**CITY OF ST. HELENS PLANNING DEPARTMENT  
STAFF REPORT**

Subdivision Preliminary Plat, **SUB.1.22**  
Subdivision Variance, **V.1.22**  
Sensitive Lands Permit, **SL.1.22** (significant wetlands)  
Sensitive Lands Permit, **SL.2.22** (steep slopes)  
Sensitive Lands Permit, **SL.3.22** (drainageways)

**DATE:** March 1, 2022  
**TO:** Planning Commission  
**FROM:** Jacob A. Graichen, AICP, City Planner

**PROPOSAL:** 66 lot Planned Development Subdivision Preliminary Plat

**EXISTING CONDITIONS PLAN**  
SCALE: 1" = 60'-0"

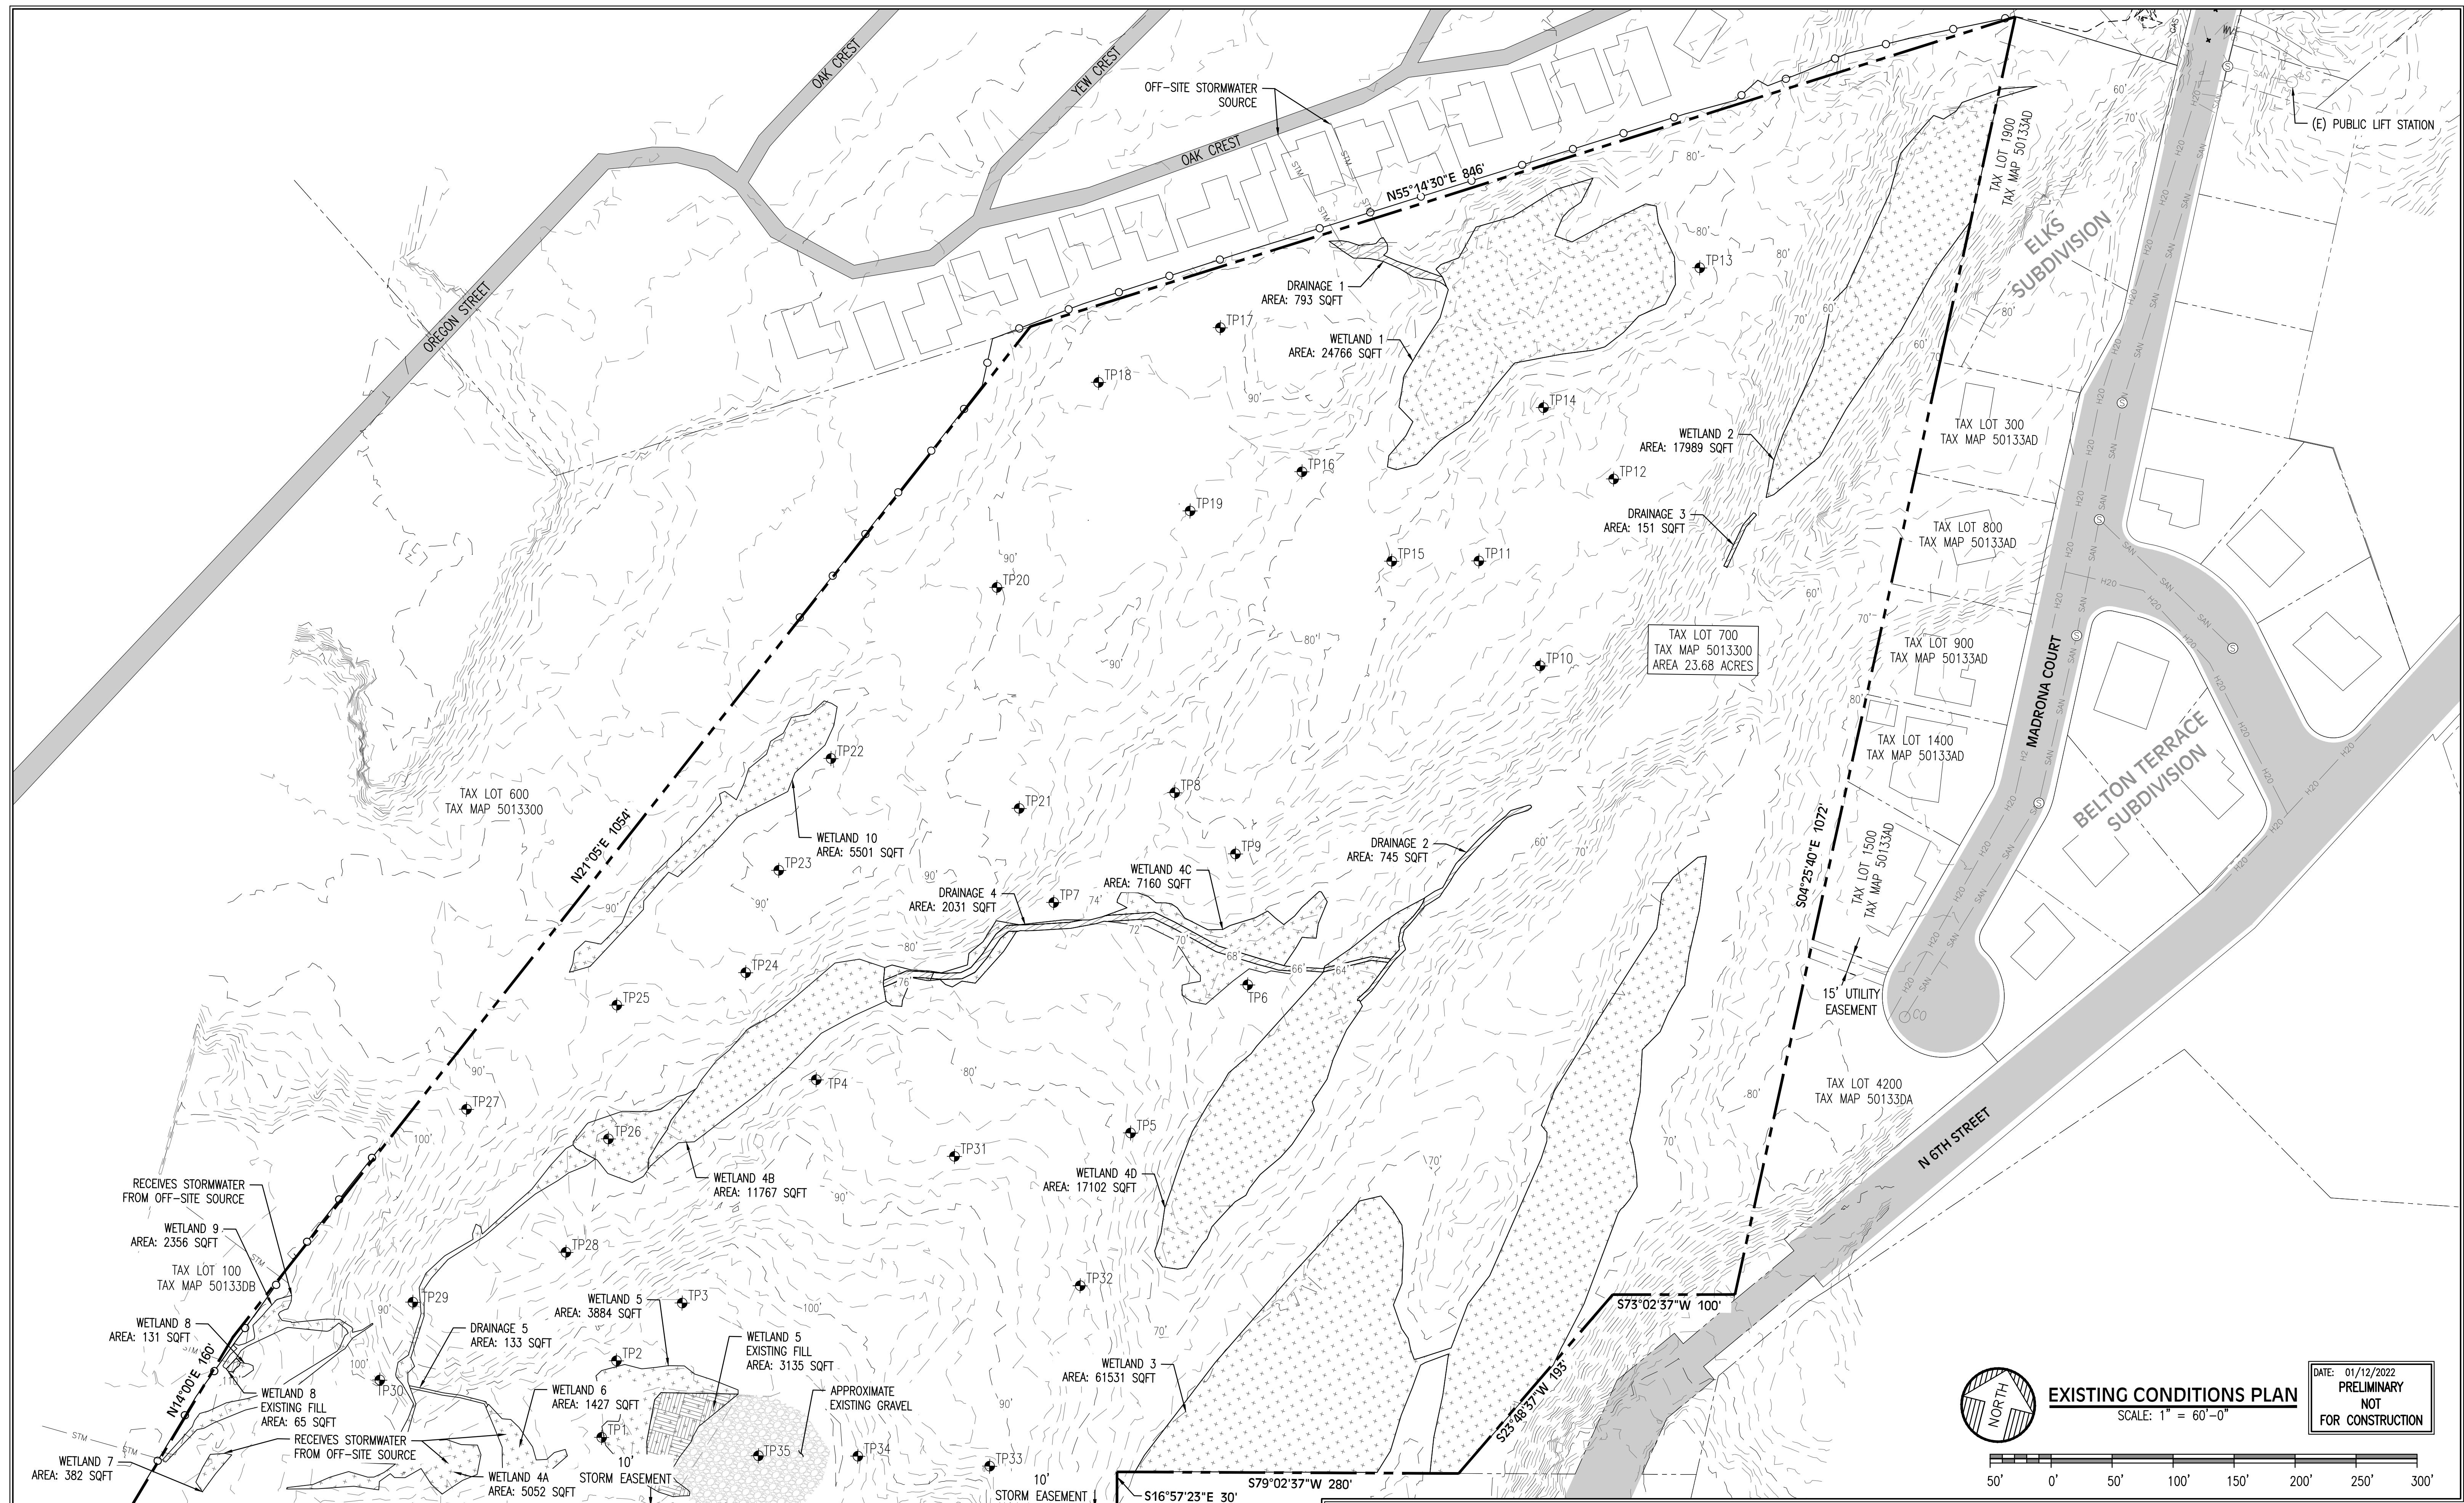
**Discussion:** If you look at the existing conditions sheet C-1 and compare to the overall grading plan, there are slopes >25% throughout the site. Some of these steep slope areas are within the area subject to be developed with streets and lots.
